Access Compliance Report

Public Rights-of-Way

| Intersection ID: 10037290 | Main Street: SARDIS_RD_NORTH | Cross Street: N/A | Location: NE |
| ADA ID: CAE2010350EE | Ramp Type: Perp | Initial Pass/Fail: Fail | Overall Compliance: No |

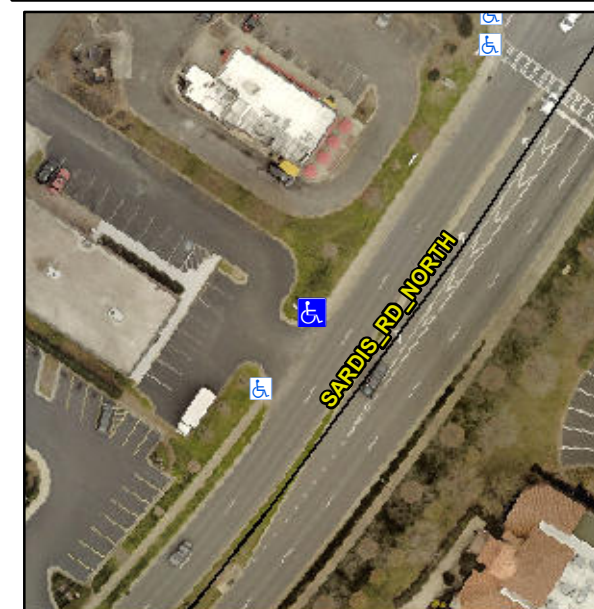
R304.5.1, R304.2.2, R304.5.3

| Compliance | Description | Data | Compliance | Description | Data |
|------------|-----------------------|-------|------------|-----------------------------|------|
| N/A | Ramp Length (in) | 71.0 | No | Ramp Slope (%) | 8.6 |
| No | Ramp Width (in) | 34.0 | No | Ramp XSlope (%) | 3.7 |

Remove & Replace Entire Ramp.
